# Ultraroof Beam Bracketry

Ultraroof Continuous Improvement Notice

# IMPROVED HIP ASSEMBLY - EQUAL PITCHES

Job No.: 4086 03/19 V2 WPBIG002

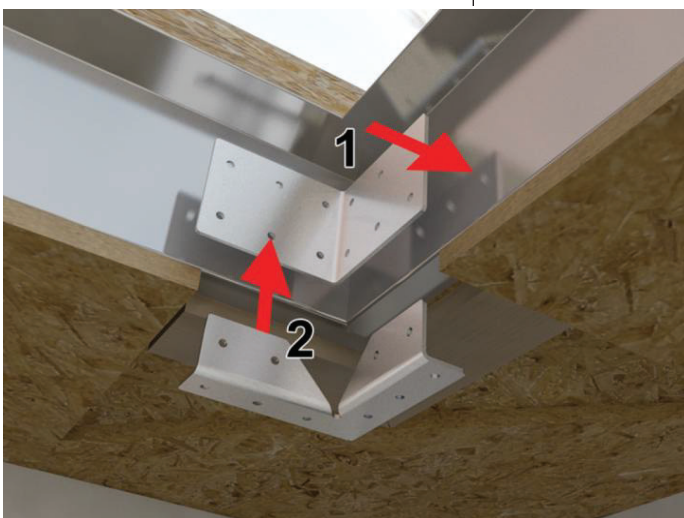
Following customer feedback your Ultraroof eaves beam has been updated to include additional brackets on the internal corners to support the mitred joint. If you receive these brackets with your order please fit as shown below.

Offer the supplied brackets to the eaves beam as shown and screw fix into position with the 13mm long fixings provided (CHA006). Note that cleat strap WPBBF090 is only required on 90° mitres.

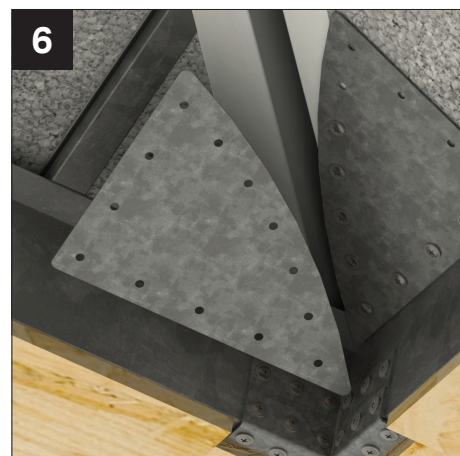
1  
The Ultrarroof hip design has been updated; extending the steel and aluminium components over the beam mitre for an improved structural connection.

2  
In equal pitch situations the beam setout shelf remains the same as current.

3  
The hip assembly features a square cut beam overhang and in-line hip wings.

4  
When in position, the hip should sit on the beam panel shelves as shown and be fixed as described in the main installation guide.

# IMPROVED HIP ASSEMBLY - VARIABLE PITCHES

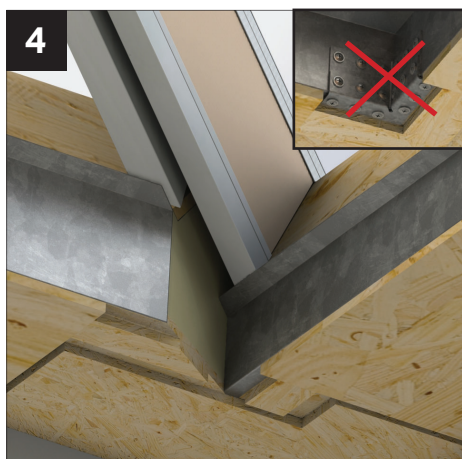
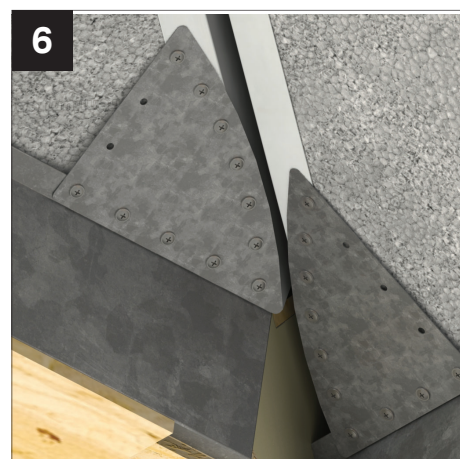
**1**  
In variable pitch situations the beam setout shelf is asymmetric, with the longest side relating to the beam with the steepest pitch – see location plan.

**3**  
The hip assembly features a notched beam overhang and offset hip wings. The notch should be oriented towards the beam with the steeper pitch.

**4**  
When in position, the offset hip wings should sit on the beam panel shelves as shown and be fixed as described in the main installation guide. **NOTE: INTERNAL BEAM CORNER CLEATS NOT SUPPLIED IN VARIABLE PITCH SITUATIONS.**

**6**  
Position and fix the internal hip retaining plates using 18 x CHAA 006 screws provided. **NOTE: THE ORIENTATION OF THE PLATES CAN BE CHANGED TO ALLOW FOR OPTIMUM FIXING AS SHOWN.**
